The Sandstone Precinct: MOD 7 Design Report

Document Number
SP-RPT-E-MAKE-0005

MOD 7 Design Report

Bridge Street view comparison

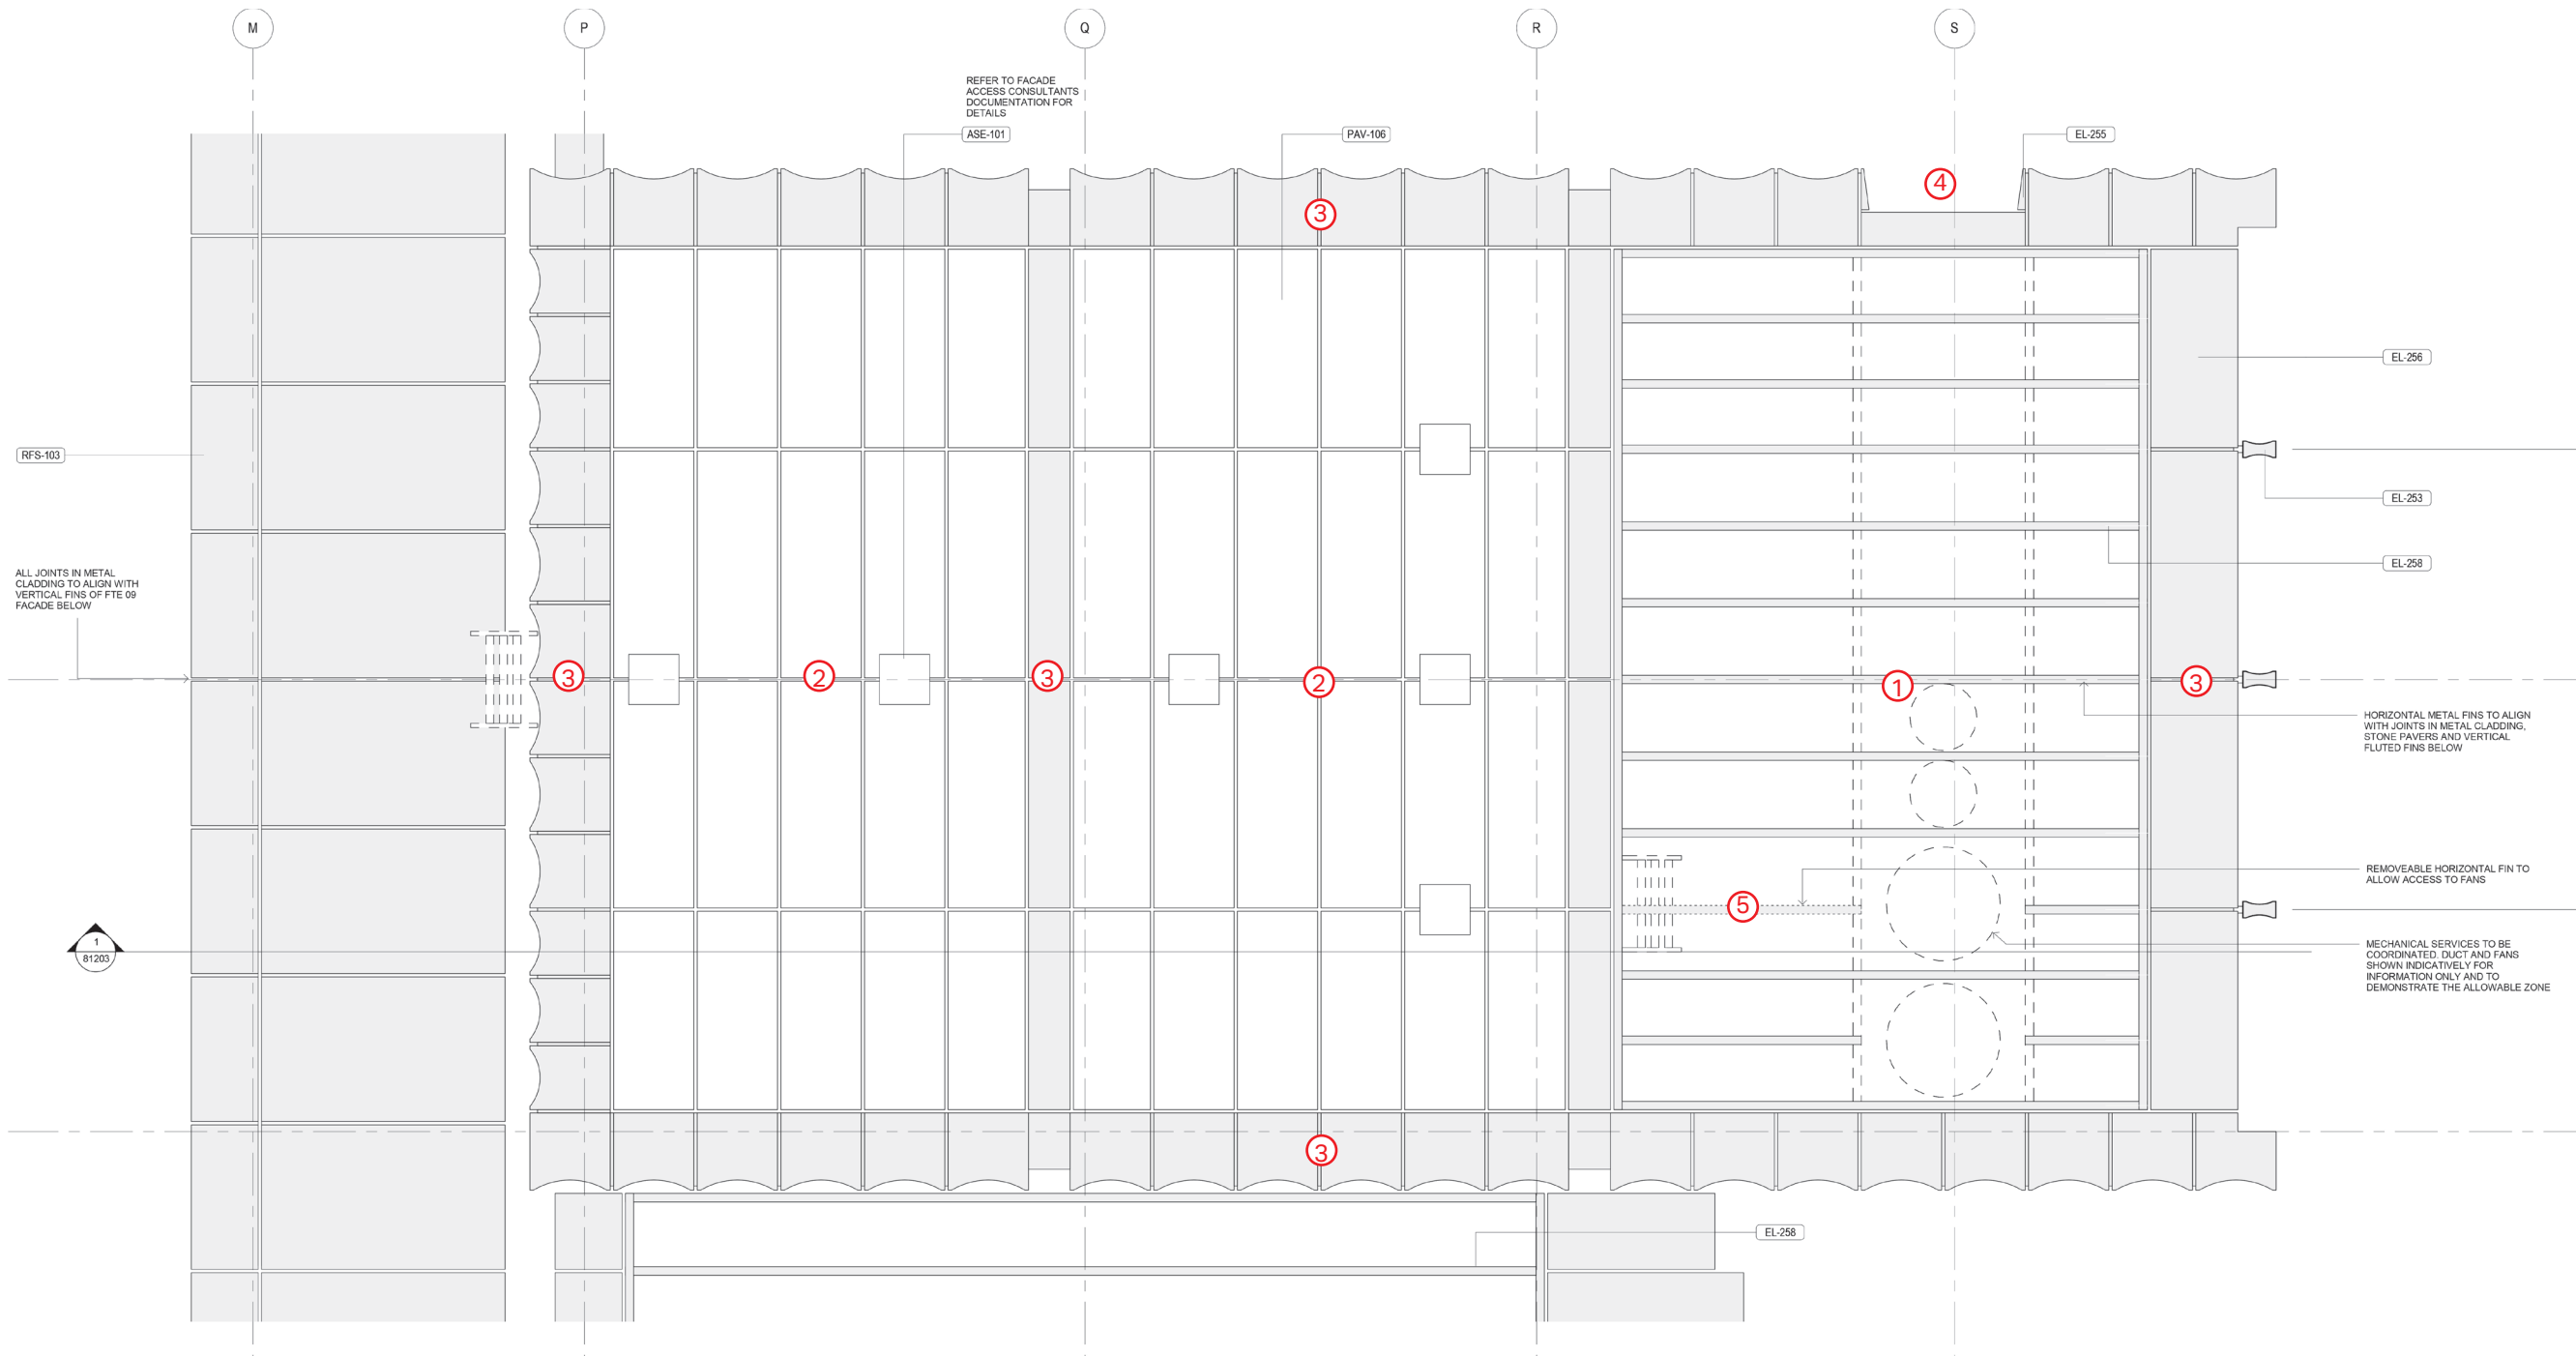
- Changes include:
- 1. Architectural louvre with vermin mesh and weatherproof mechanical air intake louvre behind
 - 2. Minor updates to the cooling tower massing. Views from Bridge street are largely unaffected by the cooling tower updates (following pages), as the roof shape is maintained and has only shifted 80mm south

Cooling towers

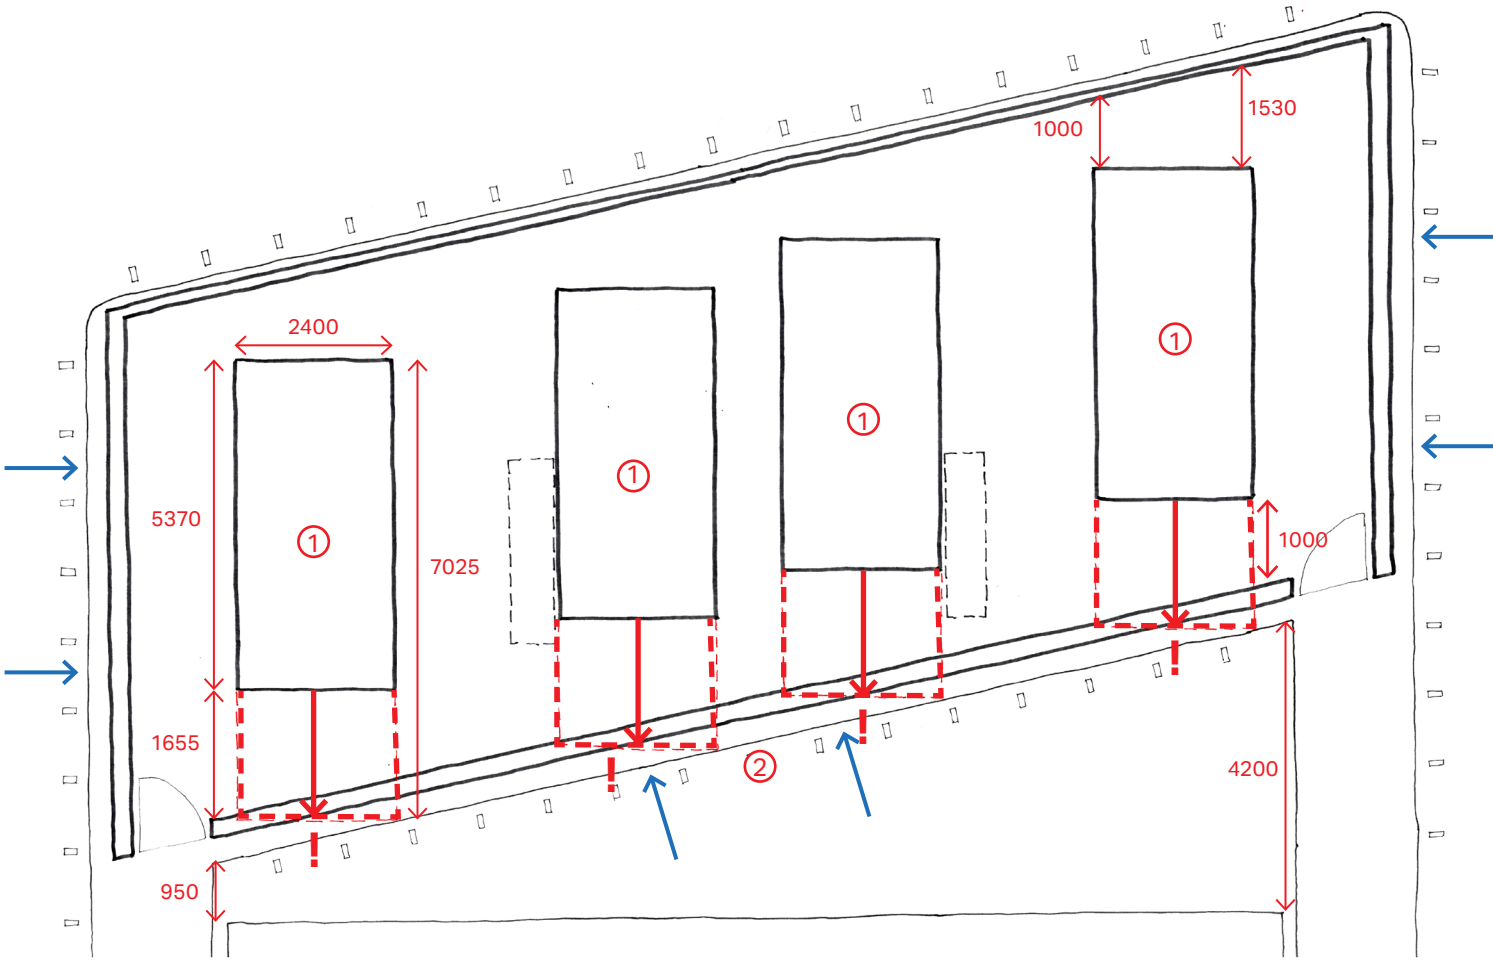
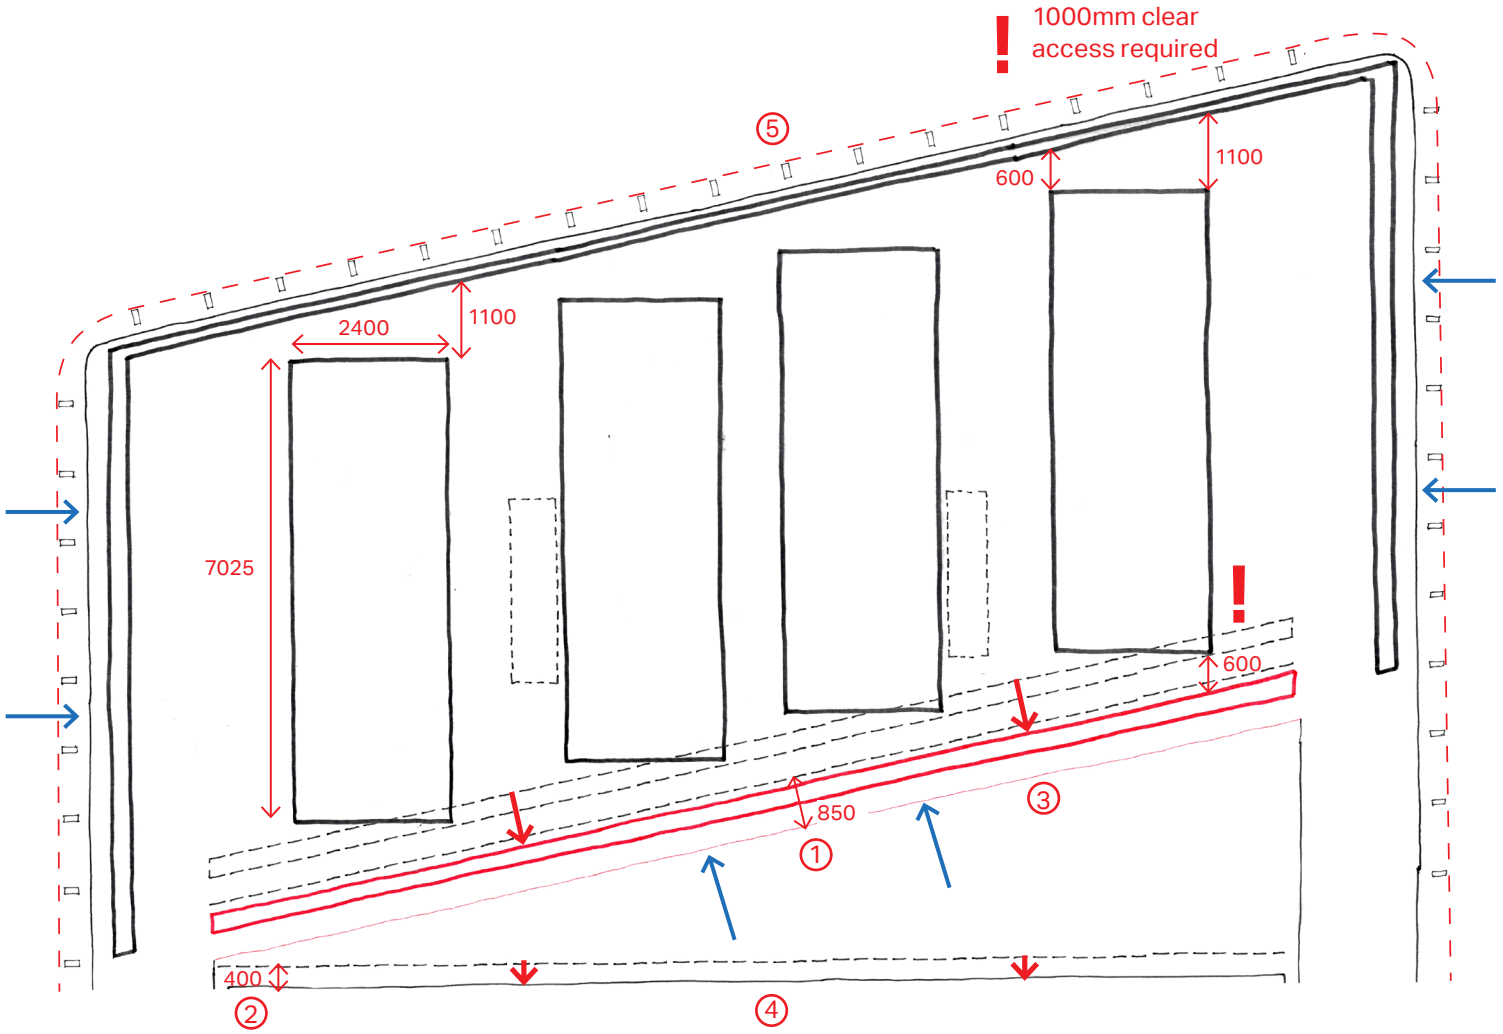
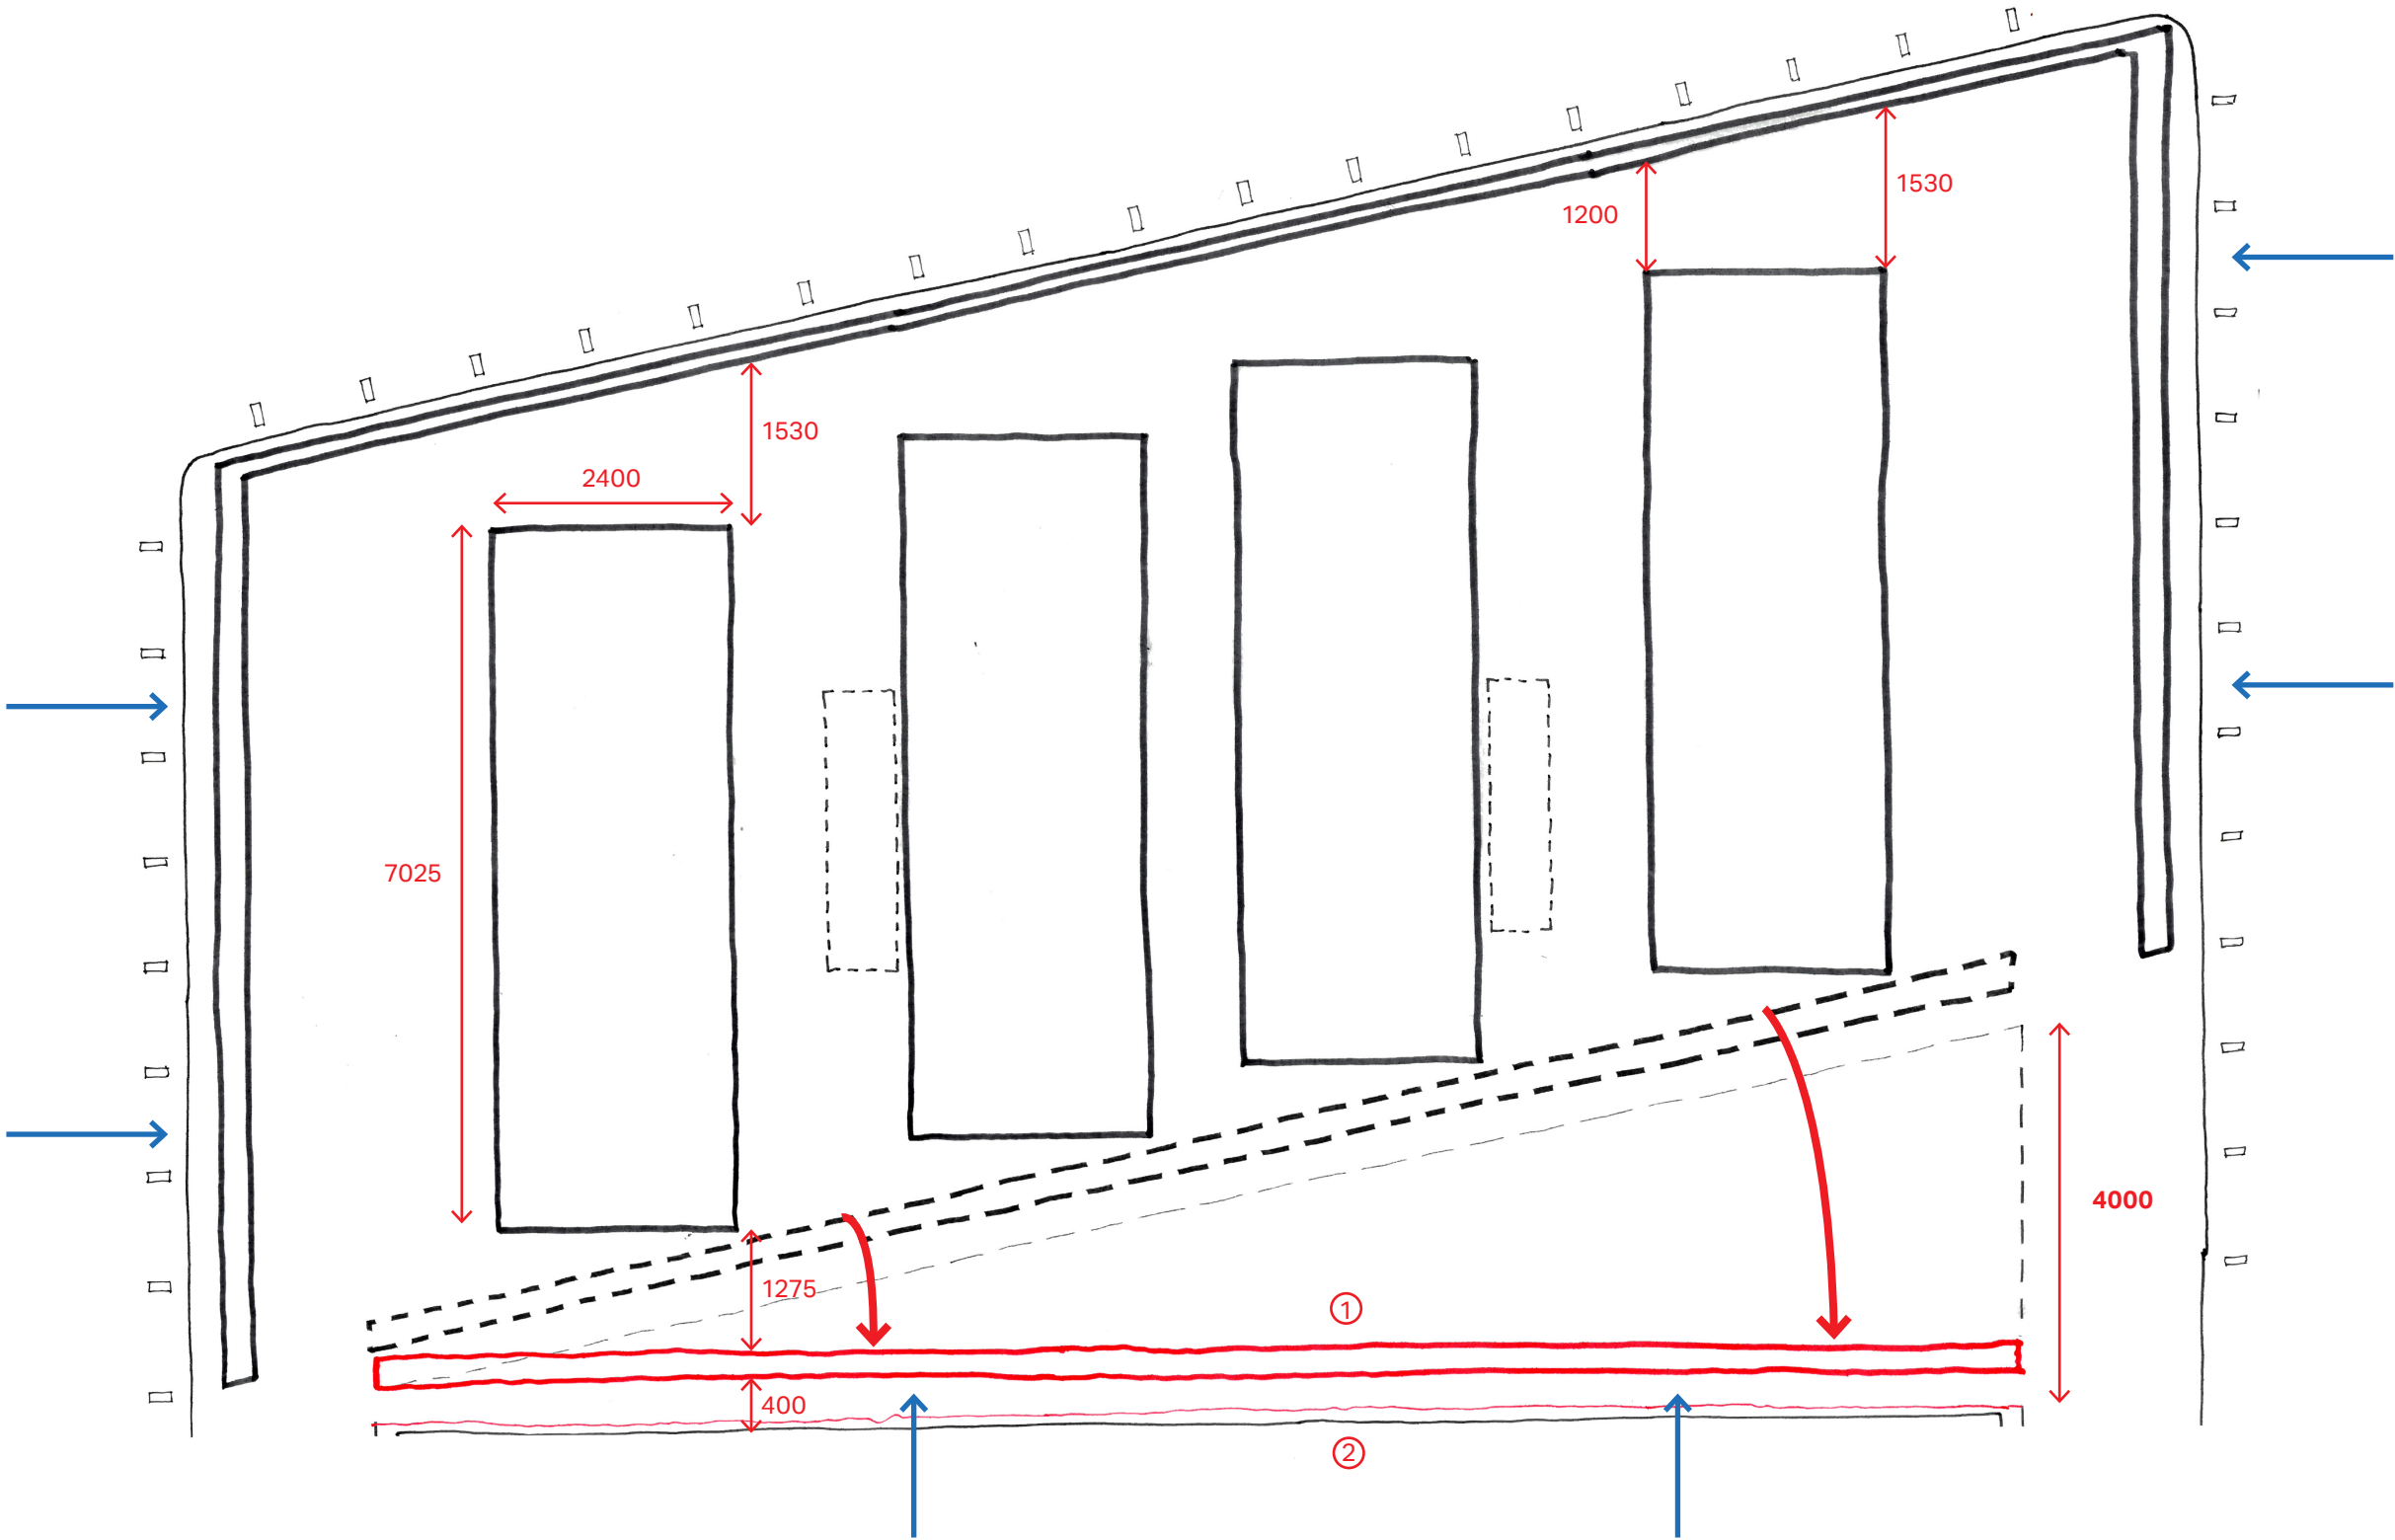
- 1. Due to the changing use of the Lands Building to include more function spaces, the cooling towers have become approximately 1650mm longer since the MOD 3 proposal.
- 2. Cooling towers (model VTL-272-P) extend through the proposed facade line impacting the massing of level 9

- 1. Southern facade of the cooling towers is moved south by 850mm to allow for a 600mm path around the cooling towers
- 2. Minimum 400mm zone to allow for appropriate build up for concrete hobs and separation of facade types
- 3. Architectural fins deleted to maximise space
- 4. Courtyard facade pushes out to accommodate for the larger cooling towers
- 5. DA envelope restricts the ability to push the façades towards the north, east and west
Insufficient space (according to Equilibrium)

- 1. In order to accommodate for a minimum of 1200mm around the cooling towers (as requested by the mechanical engineer and subcontractor) , the southern facade would need to be pushed out by 4m to align with the courtyard facade below.
- 2. Architectural fins deleted to maximise space
